1941
ORME ST. - EL. QUENTIN TO W.L. BLUFF
30' CONC WITH INTEGRAL CURB

PAVING PLAN
1941
ORME ST.
EL. QUENTIN
W.L. BLUFF

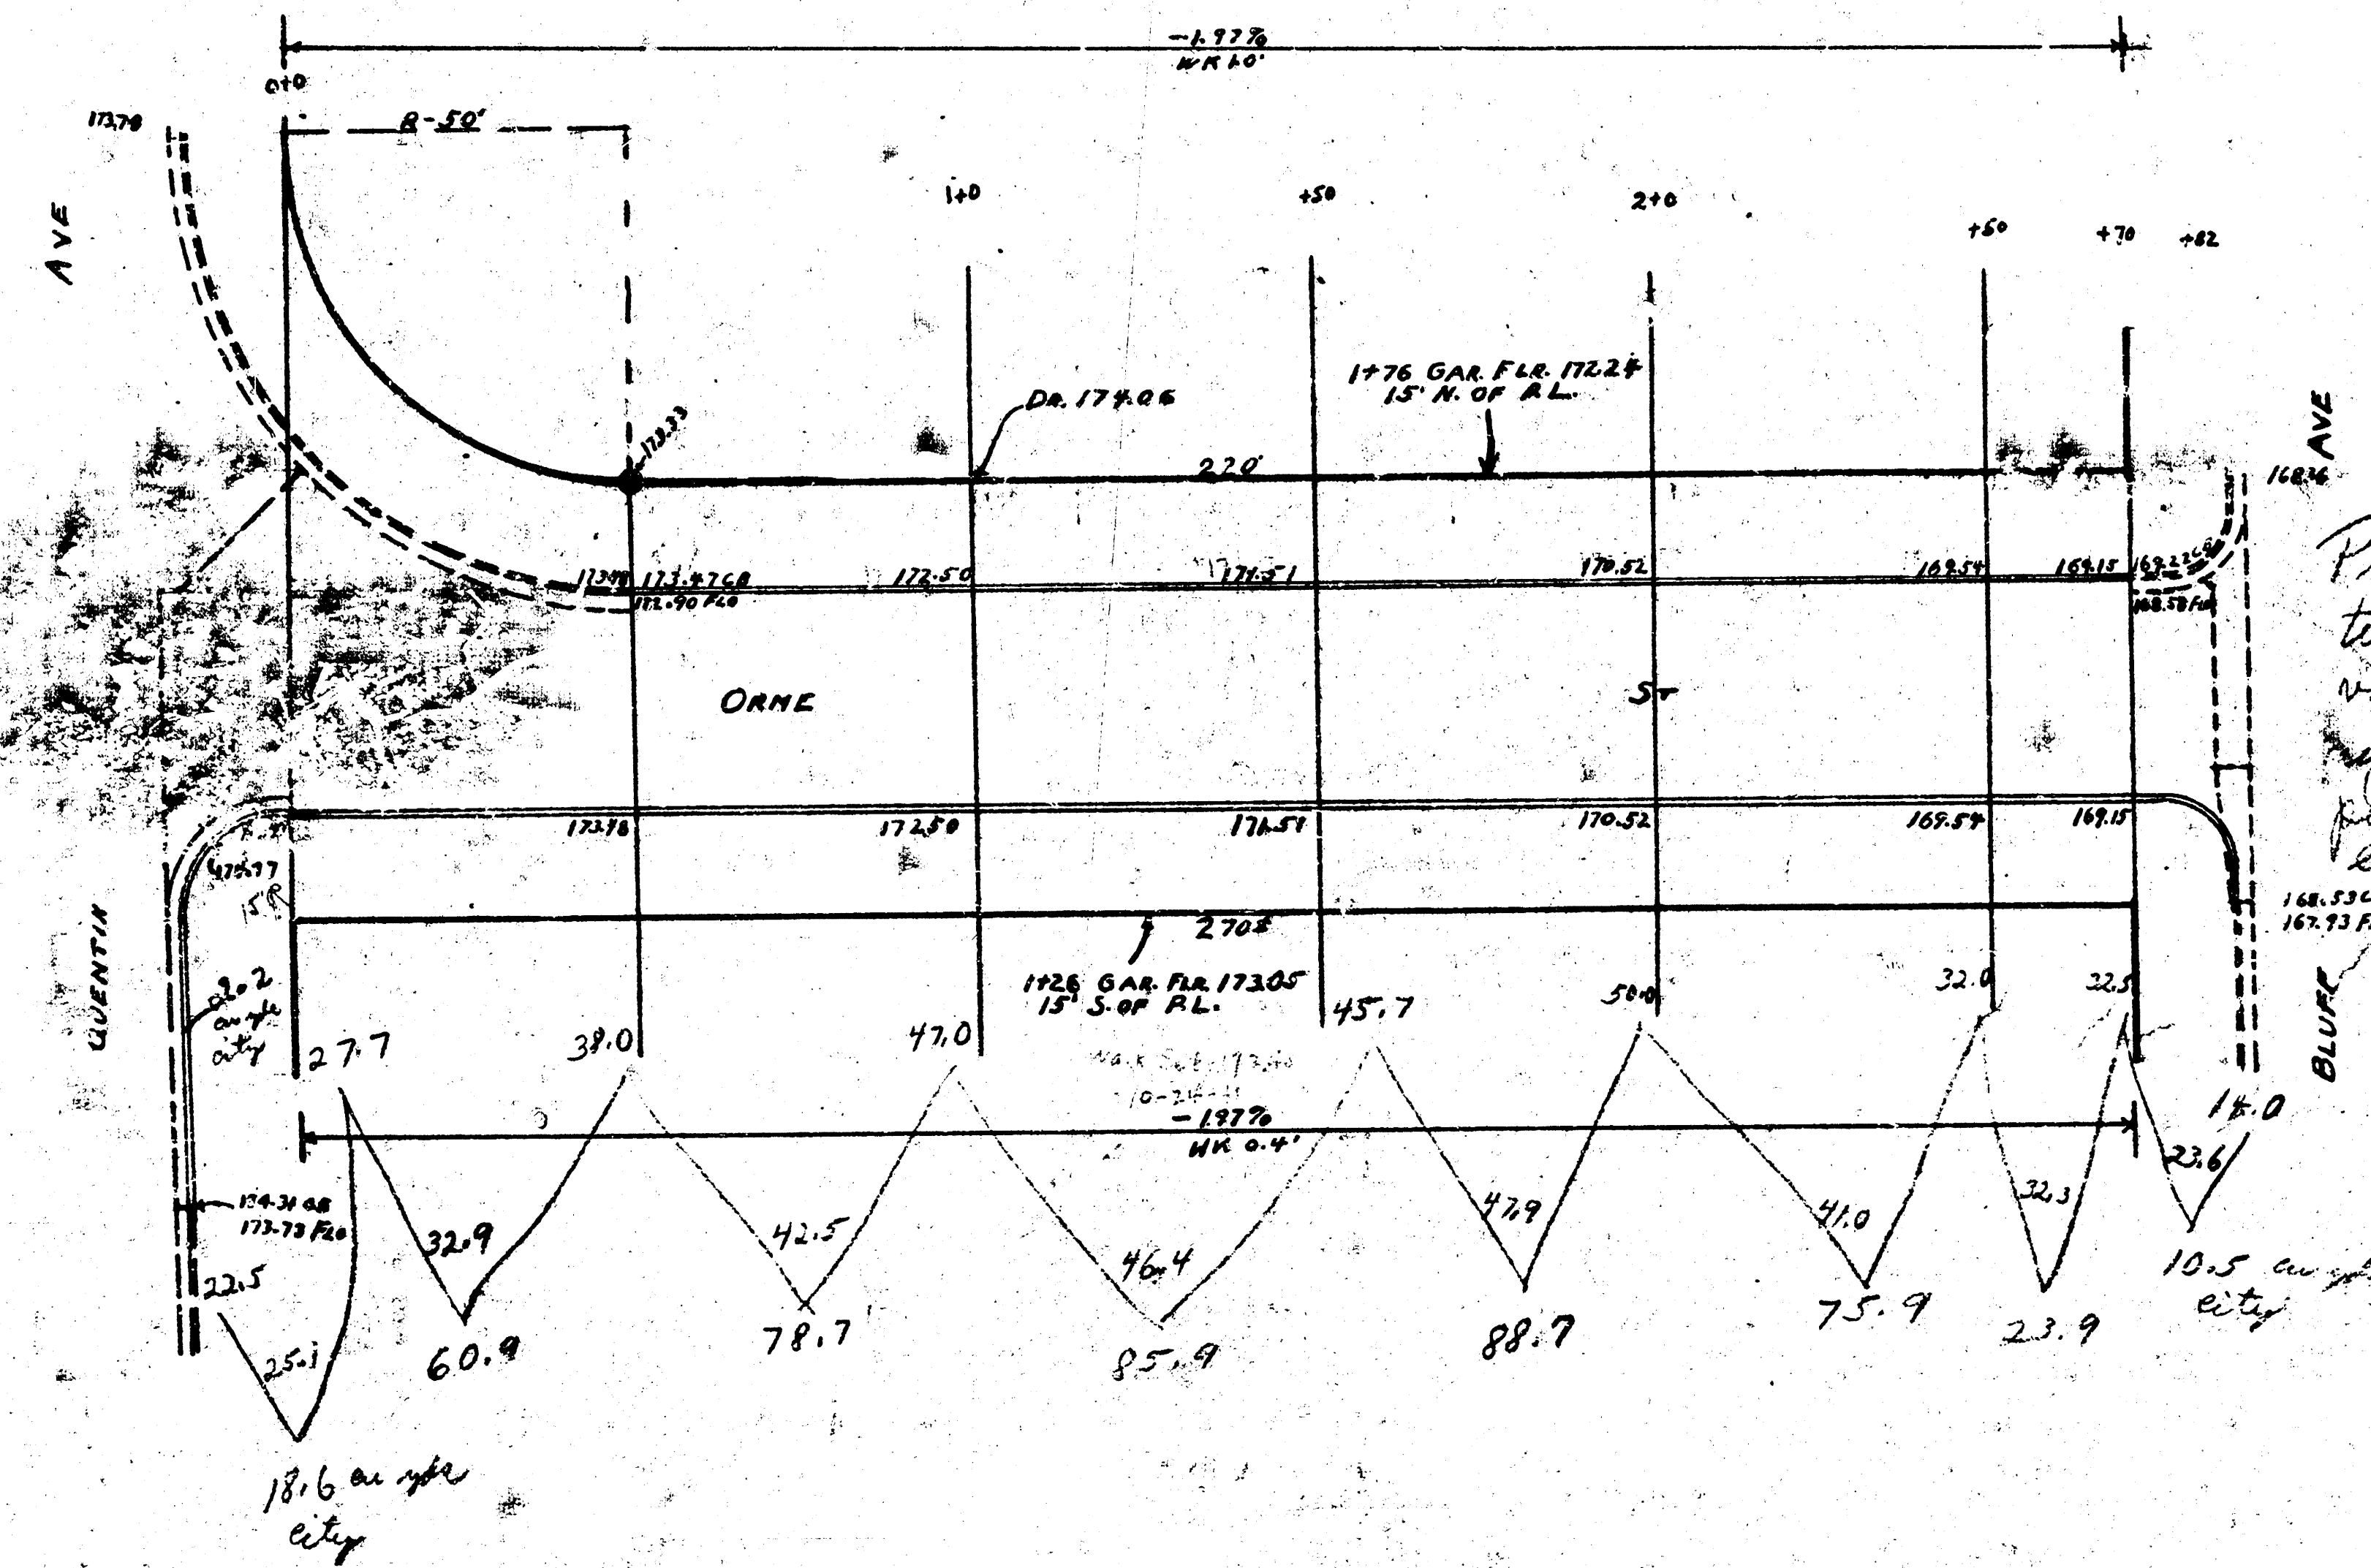
Probably advisable
to remove existing
valley gutter and
replace with 6"
pavement unless in
excellent condition
P.L.K.
